#### ADDENDUM NUMBER 3

Dated July 16, 2015

Clinton Keith Road Construction Project – Phase 2  
From Whitewood Road to Leon Road  
In the City of Murrieta and French Valley Area  
Project No. B2-04722

DETAIL A  
PEDESTRIAN WALKWAY

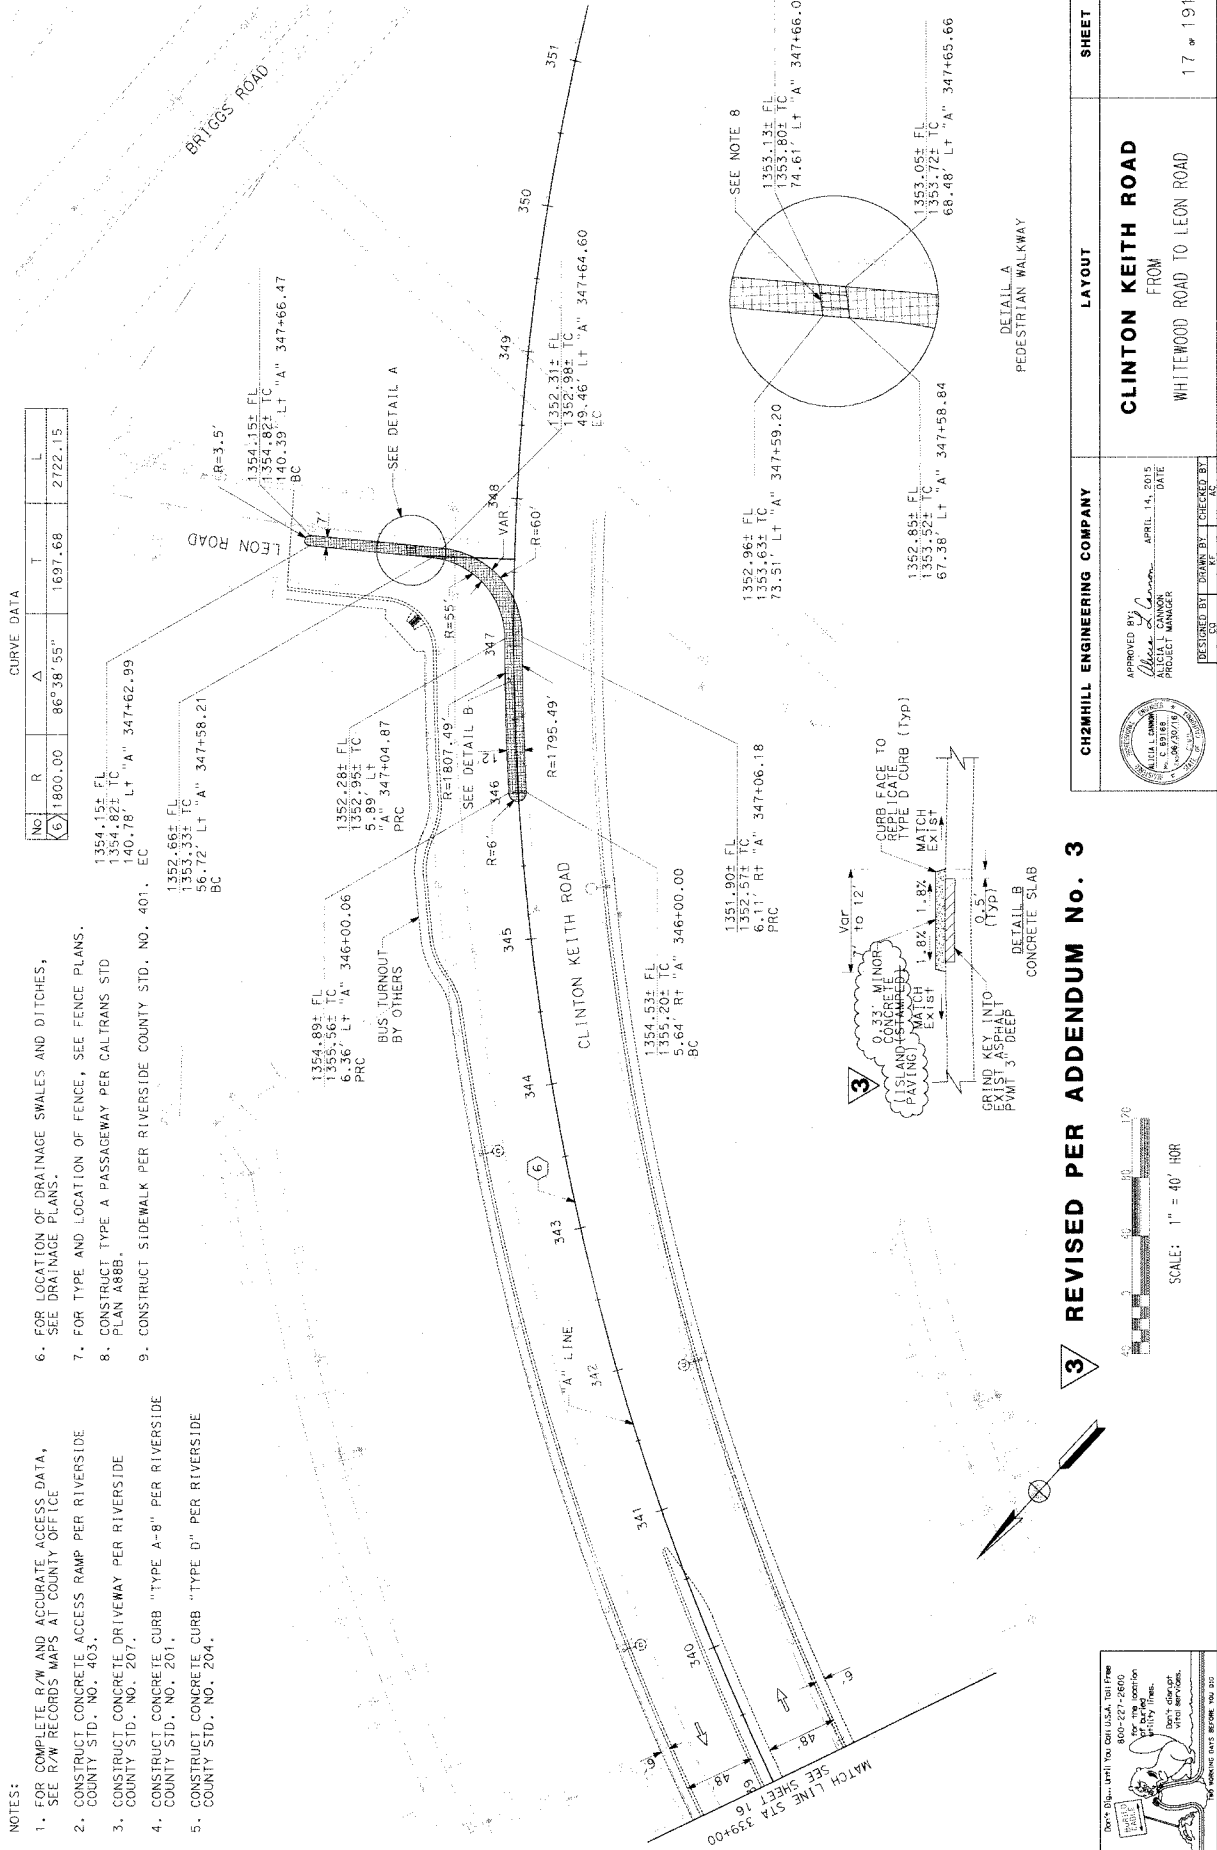
3 REVISED PER ADDENDUM No. 3

CH2MHILL ENGINEERING COMPANY	CONSTRUCTION DETAILS	SHEET
APPROVED BY: <i>Alvin J. Carron</i> DATE: APRIL 14, 2015 PROJECT MANAGER	CLINTON KEITH ROAD FROM WHITWOOD ROAD TO LEON ROAD	39 of 191
DESIGNED BY: <i>Alvin J. Carron</i> CHECKED BY: <i>Alvin J. Carron</i>	PROJECT: B2-0472 ARCHIVE NO.:	962-W

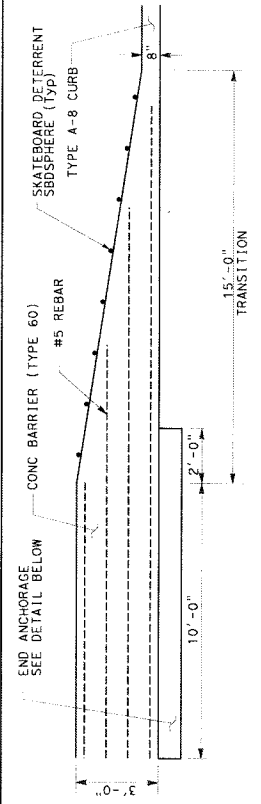
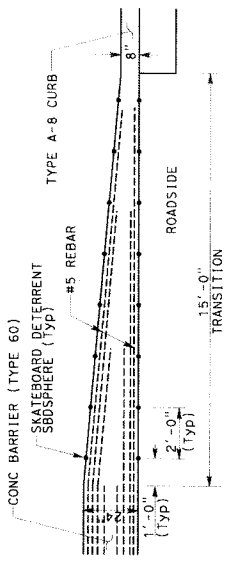
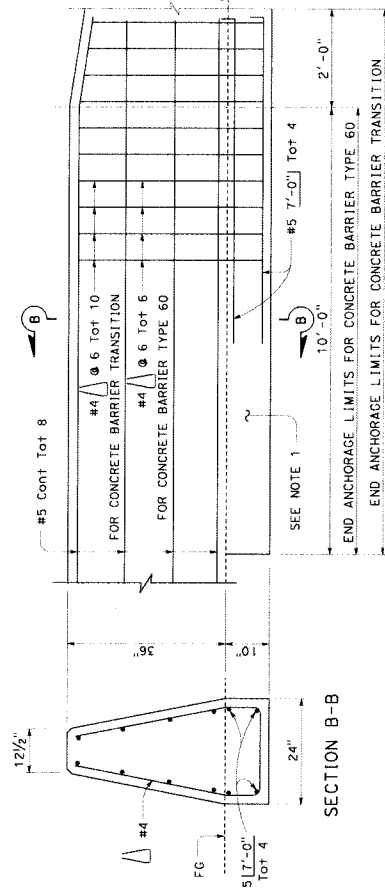
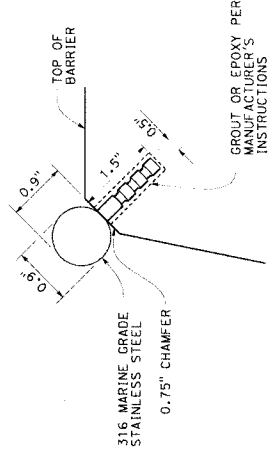
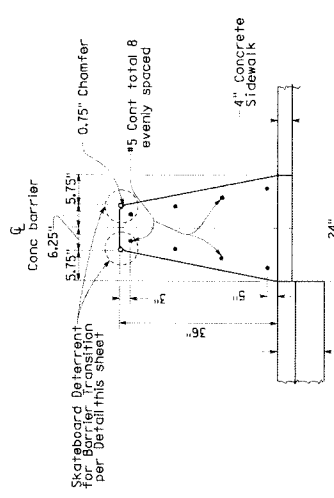
Response	Yes, temporary fence (Type CL-6) shall be constructed as shown on the plans. This fence is the same as Caltrans Standard Plan A85.
<b>44</b>	Question	Is there a detail for the Type 60E Modified Concrete Barrier (Sheet 39 2-lane option & Sheet 41 4-lane option)?

Response	See Addendum No. 3, Revised Plan Sheets. Plan sheets 39 of 191 (2-lane) and 41 of 195 (4-lane) have been revised. Post spacing is 10' maximum. Contractor may reduce spacing to fit the terrain.
56	Question	For Items 106 & 240 – Wire Mesh Fence (3/8" x 3/8" mesh), are these chain fabric or woven wire mesh? County Provision Section 80-3.02 calls for galvanized chain link fabric but Details on Sheet 41 shows 3/8" galvanized wire mesh (square), please clarify.

Response	See Addendum No. 3, Revised Plan Sheets. Plan sheets 39 of 191 (2-lane) and 41 of 195 (4-lane) have been revised. Special Provision 80-3.01 refers to chain link fabric, 11 gage galvanized.
57	Question	For Item 249 – Chain Link Railing (Item Code 833020), do we need to follow County Provision Section 83-1.02G(2) that calls for PVC coating or is galvanized finish only, please clarify.

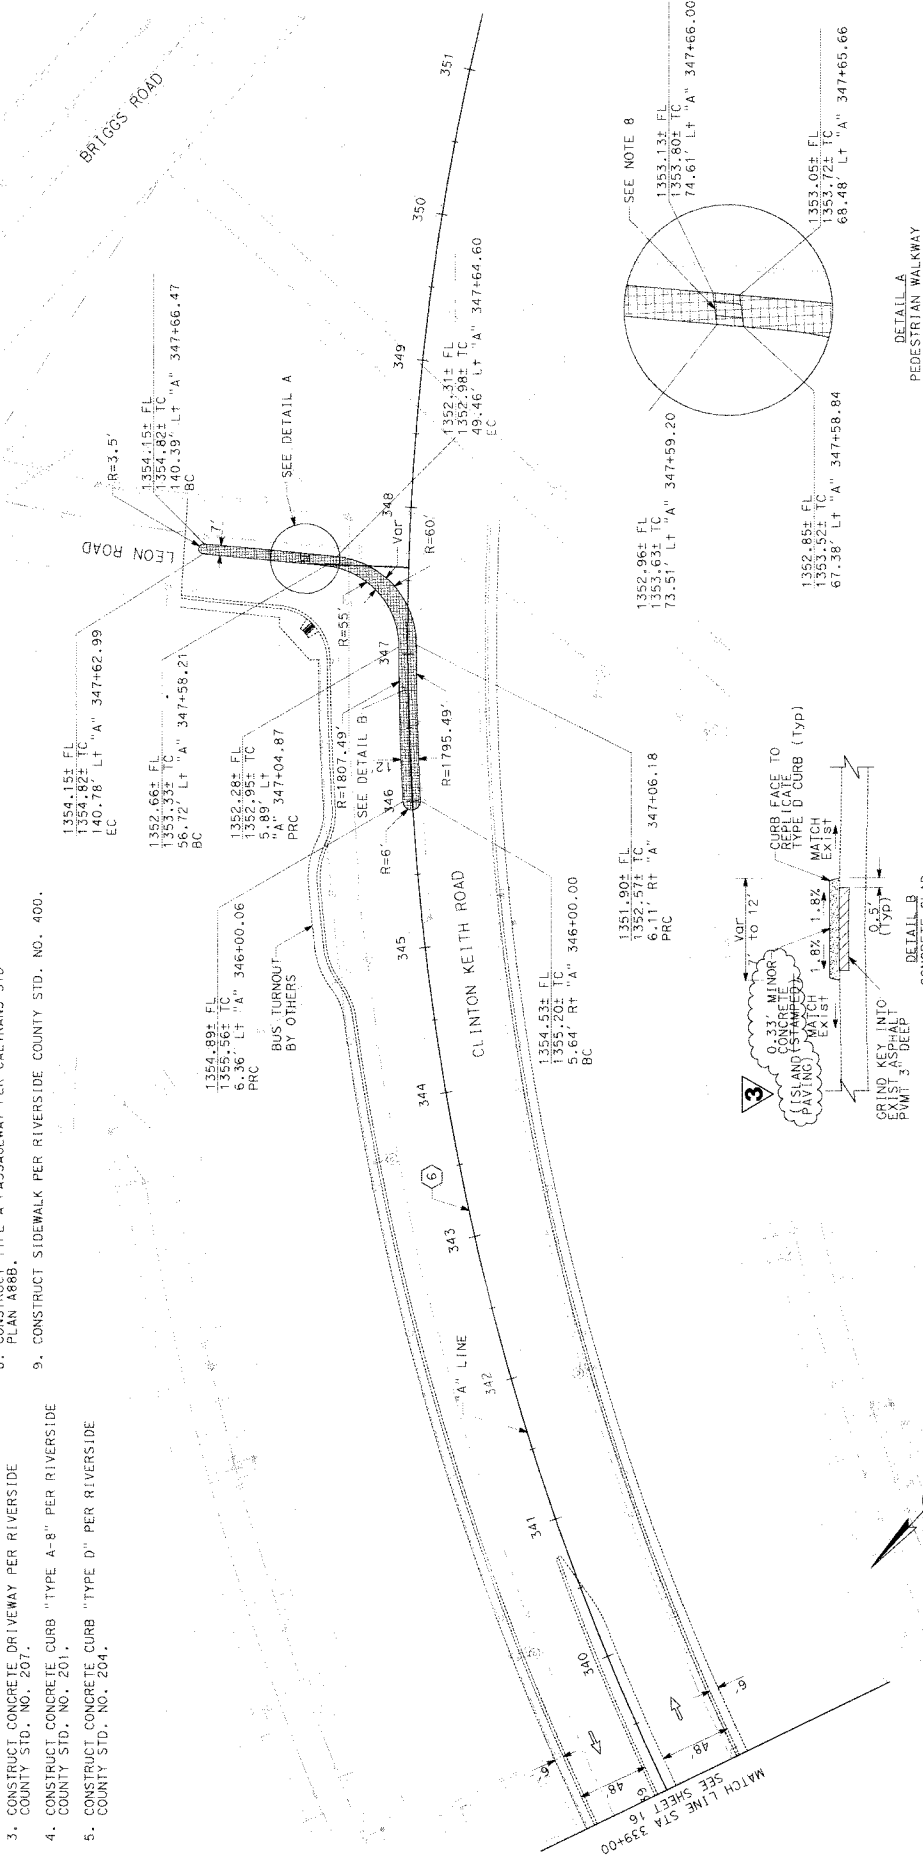
3 REVISED PER ADDENDUM No. 3
